# NEGATIVE INPUT HYBRID PRE-AMPLIFIER

| Title | PREAMPLIFIER(for channel no 1) | |

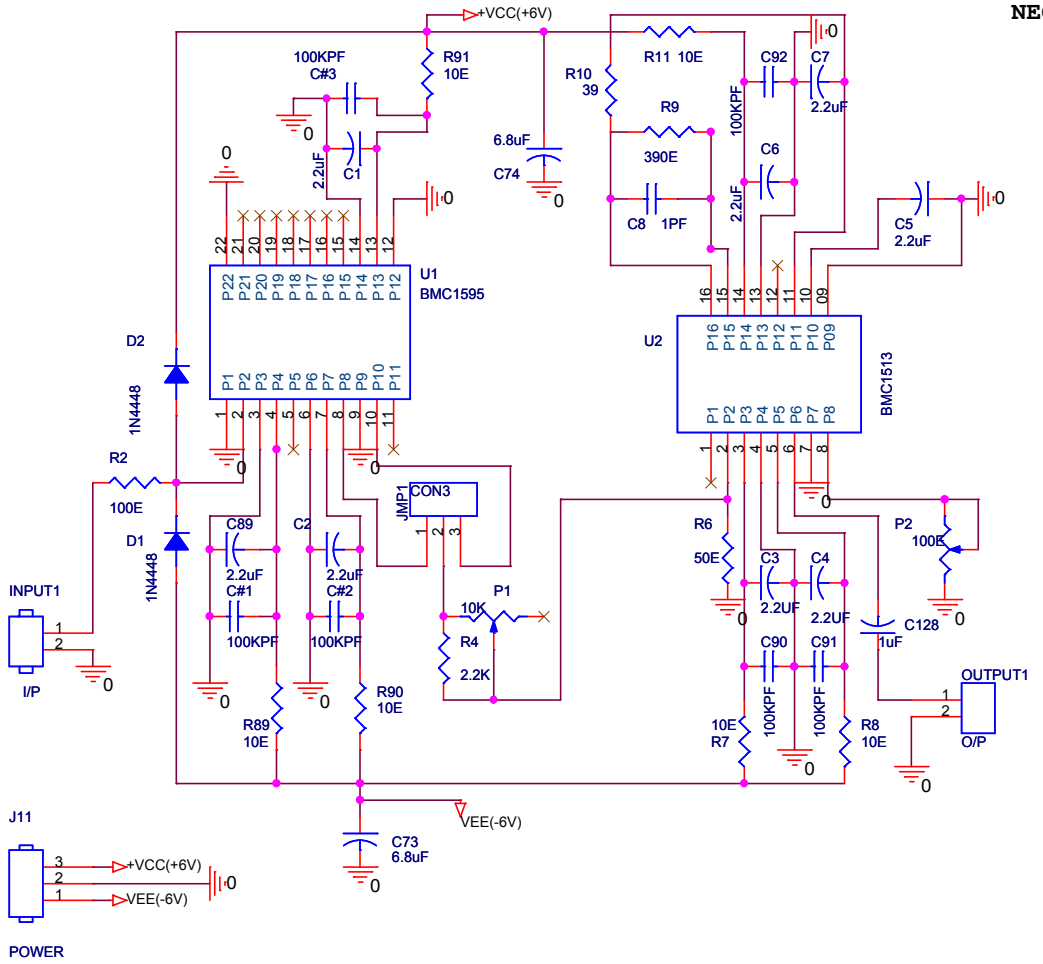
C#1,C#2,C#3 (LABEL AS IN CIRCUIT DIAGRAM )SOLDER ON IC PINS NO LABEL IS PROVIDED ON PCB
FOR +VE INPUT R3 SHOULD BE 50 OHM FOR -VE INPUT R3 SHOULD BE OPEN
SHORT R5 ON PCB
KEEP R1 OPEN LABEL ON PCB
KEEP C9 OPEN LABEL ON PCB
SHORT R2 ON PCB

R2 SHORT ON PCB

R6 IS PLACE NEXT TO R9 ON PCB,NO LABEL IS PROVIDED

C5 IS PLACE NEXT TO C6 NO LABEL IS PROVIDED ON PCB

JMP1= 1-2 FOR -VE INPUT,2-3 FOR +VE INPUT
